# SUPPLEMENTAL INSTRUCTION

PROJ.: **Boys and Girls Club Prince of Wales**  
PROJ. No.: **1716**  
DATE: **May 29, 2018**  
S.I. No. **S.I. - 027**

# INFORMATION BULLETIN

Gypsum board bulkhead, North wall of Dance Studio

ASK NO.  
**ASK-009A**

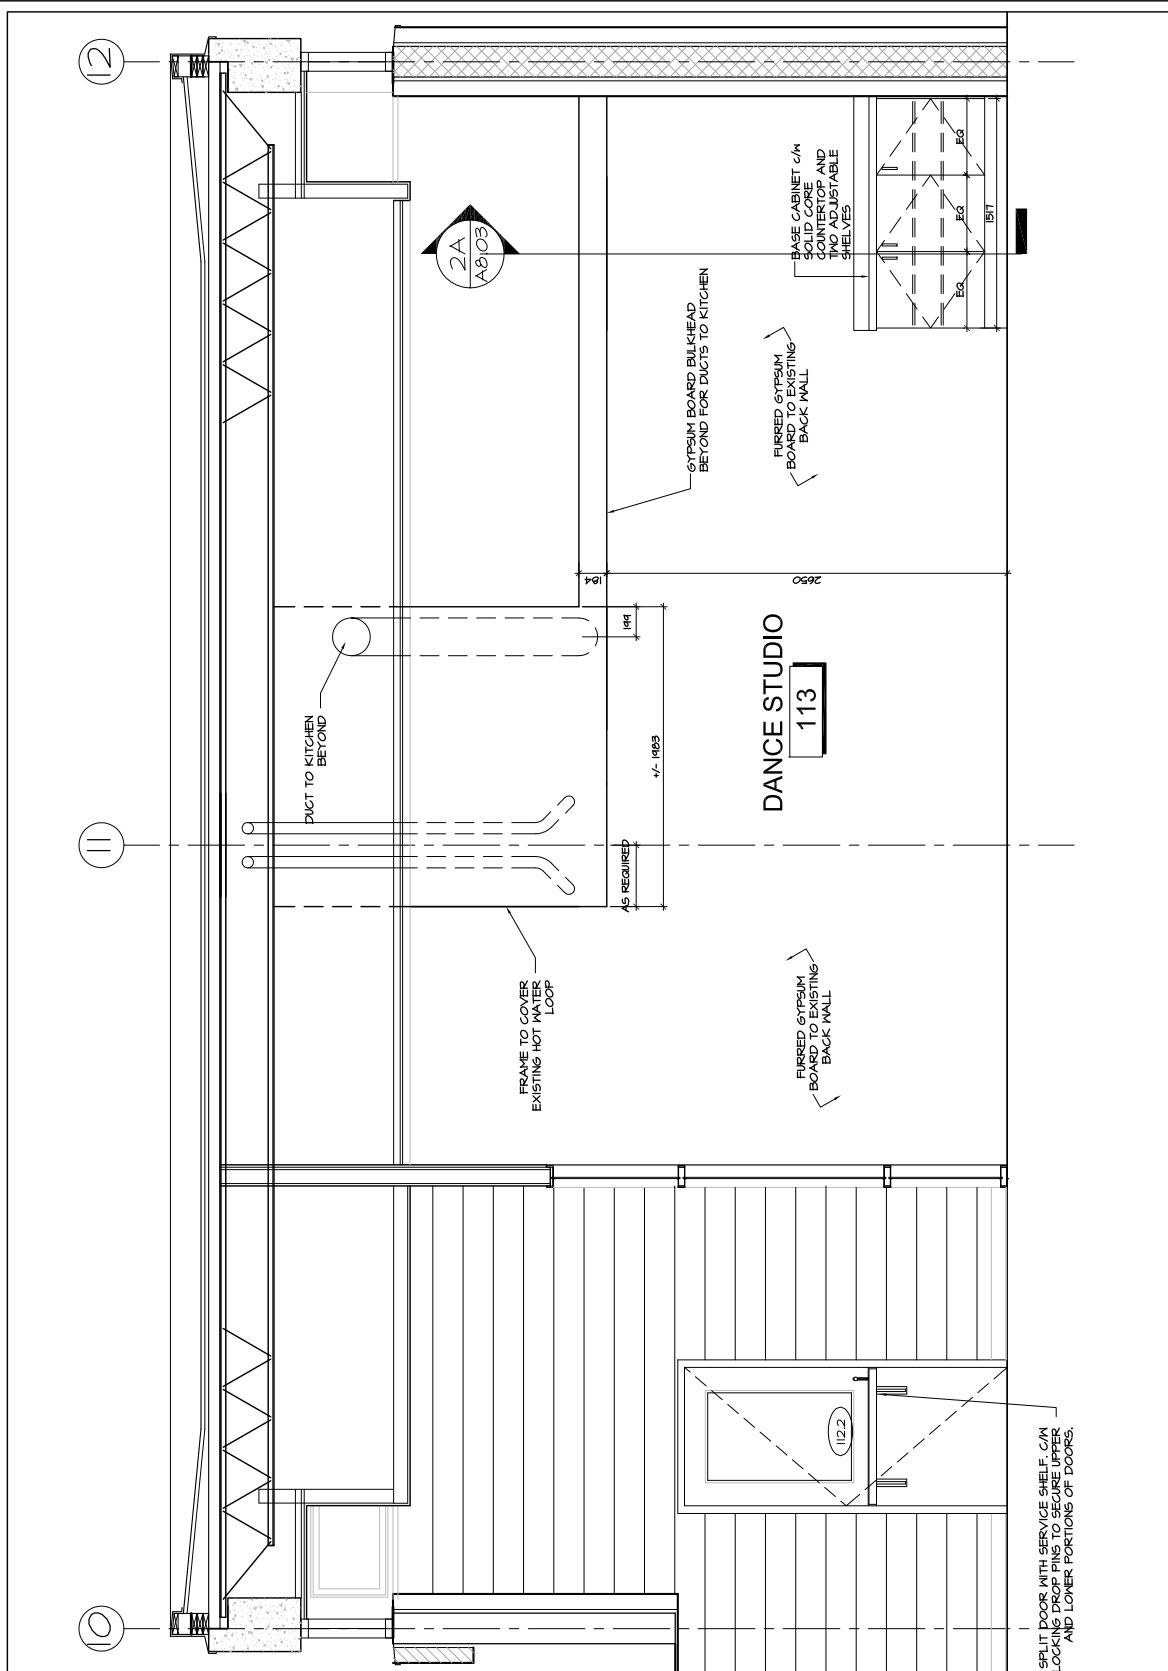
.1 Provide a gypsum board bulkhead surrounding the existing ductwork and mechanical heating pipes at the north wall of the dance studio as per the attached architectural sketches ASK-009a, ASK-009b
